From: [Lowman, Donald](#)
To: [Royal Pond](#)
Cc: [Von Till, Bill](#); [Saxton, John](#); [Quintero, Jessie](#); [Mike Griffin](#)
Subject: Strata Energy 11.3(C) Amendment Request
Date: Tuesday, November 28, 2017 11:32:00 AM
Attachments: [Amendment 8 SER V1_Rev6.docx](#)

SAFETY EVALUATION REPORT
REVIEW OF APPLICATION TO AMEND LICENSE CONDITION 11.3(C), LICENSE SUA-1601,
STRATA ENERGY, INC. ROSS IN SITU RECOVERY FACILITY, CROOK COUNTY, WY

DOCKET NO.: 040-09091

TECHNICAL REVIEWER: John L. Saxton

Figure 1. Well Yields of 0.5 GPM as a Function of Available Water Column, Transmissivity and Storativity

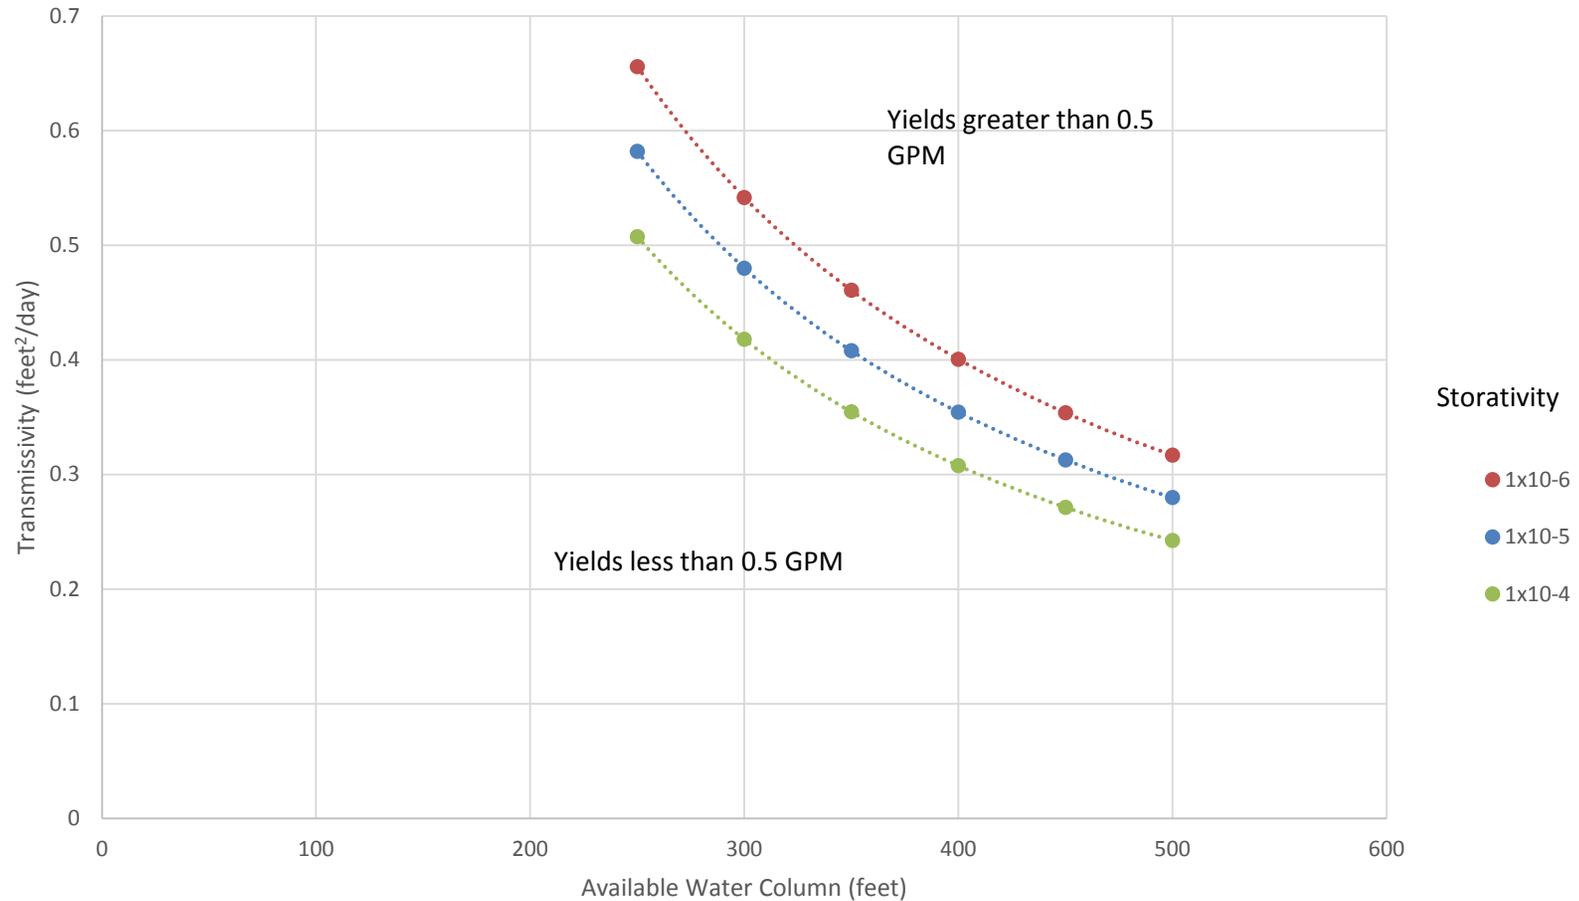
The NRC staff finds Strata's proposed criterion 5 acceptable because it is based on established State of Wyoming criteria. Furthermore, staff find the procedures used by Strata acceptable (with one caveat listed below) because they quantify a sustainable yield for a specific well based on (1) estimates of the hydraulic properties for the aquifer in the vicinity of the well using established slug testing methodology, (2) an appropriate period for sustainable pumping, (3) utilizing actual water column in the pumping well available for cumulative drawdown, and (4) established models for non-equilibrium radial flow to a well. The assumed parameters for Strata's analysis include storativity of the aquifer (1×10^{-5}), estimated available water column with a factor of safety (20 feet above the pump intake which is 30 feet above the top of the screened horizon) and the pumping duration (365 days). The measured parameters for Strata's analysis include radius of the well screen (0.4375 feet), radius of the well casing (0.1875 feet), aquifer thickness (13 to 25 feet), available water column (static water elevation minus the maximum safe drawdown elevation) (205.8 to 493.9 feet) (Strata, 2017c). The calculated parameters for Strata's analysis include transmissivity of the aquifer and well yield. The NRC Staff finds that the assumed and measured parameters are appropriate and confirmed that Strata's calculations for the well yield are correct using Strata's assumed, measured and calculated parameters (Table 1).

The calculated transmissivities through the verification process varied from 0.01 to 1.28 square feet per day (Table 2). Using the estimate of transmissivity developed through the verification process, a safe yield was determined for each well using the method described above (Table 2). The NRC staff's estimate of the transmissivity during the verification process was consistent with Strata's calculations (within 0.05 square feet per day) for all wells in Mine Unit 1 and wells MU2-DM02, MU2-DM11, MU2-DM14, MU2-DM16 and MU2-DM19. For wells MU2-DM04a, MU2-DM12a, MU2-DM17, MU2-DM18, MU2-DM20 and MU2-DM21, staff's verification transmissivity differed from Strata's calculation (greater than 0.05 square feet per day) but did not result in a predicted well yield greater than 0.5 gpm. For those wells, staff finds that that Strata's conclusions are valid (Figure 4). For wells MU2-DM-06, MU2-DM-08, MU2-DM-09, MU2-DM-22 and MU2-DM-23, staff's verification transmissivity resulted in a predicted well yield greater than 0.5 gpm and thus did not verify Strata's calculations.

Figure 2. Examples of Curve Fitting to Strata’s Data and Estimation of Time to 0.25 Recovery

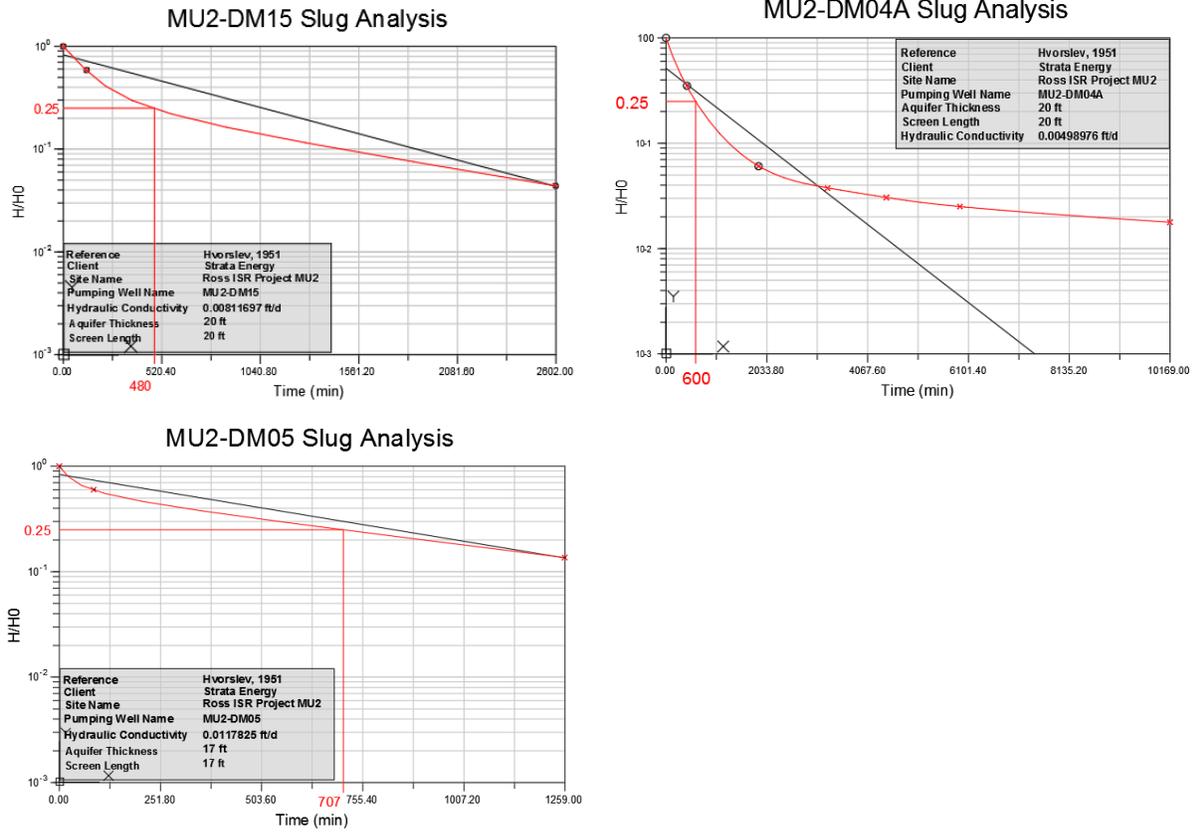
More importantly, though limited, the data for most wells indicate a non-linear (concave upward) response (see figures in Appendix J of Attachment 5 of Strata's MU1 and MU2 wellfield data packages (Strata, 2015b; 2016a)). Such behavior is attributed to non-steady state conditions (Hvorslev, 1951) or compressibility of the aquifer (Butler, 1998), either of which is not compatible with the Hvorslev method. Butler (1998) evaluated the appropriateness of applying the Hvorslev method to concave upward data. Butler found that fitting a straight line to the normalized head data in the range of 0.15 to 0.25 would provide comparable results to a Cooper method. The commercial software used by Strata recommends use of this range of data.

The suggested Hvorslev methodology for curvilinear data, however, is not based on picking two data points and drawing a line, as was done by Strata, but using the tangent to the data curve over the recommended range of values. Use of the tangent line is important because the analysis is based on revising the initial displacement based on the y-intercept of this tangent line (Butler, 1998). Here, Strata's limited data for many wells (1) did not have data within the recommended range, (2) did not provide an appropriate tangent line, and (3) did not properly estimate a new initial displacement value.

To establish whether Strata's proposal to eliminate any wells from monitoring was based on a flawed analysis, the NRC staff verified Strata's calculations by using the Cooper and Papadopulos methods to establish a transmissivity. The method typically consists of fitting the observed data to a model type curve and then establish a match point between the observed time and dimensionless time for the model curve (Dawson and Istok, 1991; Fetter, 1980). Because of the limited data, the NRC staff used a variant of the method by obtaining a match point for a selected normalized head. In this case, the NRC staff used a normalized head that was 25 percent of the initial head. To establish the normalized 25 percent head, curves were fitted to the data using Strata's graphs from the mine unit reports (for examples, see Figure 2).

In several cases, the limited data introduced an unacceptable degree of uncertainty in this analysis. If staff determined that Strata's data were insufficient for any analysis or the uncertainty in the curve assigned by staff yielded ambiguous results, then that well was eliminated from staff's verification process and, by default, included in the monitoring program.

The NRC staff determined that the data for wells MU2-DM01, MU2-DM05 and MU2-DM15 was insufficient or had sufficient uncertainty that the verification was deemed unnecessary and the wells were included in any proposed monitoring program. For the remainder of wells, the NRC staff estimated the time to the 25 percent normalized head varied between 0.2 and 13.7 days (Table 2).

Therefore, the NRC staff finds that all DM unit wells in Mine Unit 1, and the DM unit wells in Mine Unit 2 except wells MU2-DM01, MU2-DM-05, MU2-DM-06, MU2-DM-08, MU2-DM-09, MU2-DM15, MU2-DM-22 and MU2-DM-23, have a predicted yield less than WDEQ/LQD criterion of 0.5 gpm and recommends those wells be removed from the monitoring program as requested by Strata. Staff finds that predicted well yields for wells MU2-DM01, MU2-DM-05, MU2-DM-06, MU2-DM-08, MU2-DM-09, MU2-DM15, MU2-DM-22 and MU2-DM-23 cannot be verified and thus continued monitoring is required (i.e., Strata's request is denied for these wells). Strata may elect to re-perform slug tests at the wells that yield insufficient data and resubmit a request for staff to evaluate the new data in the future.
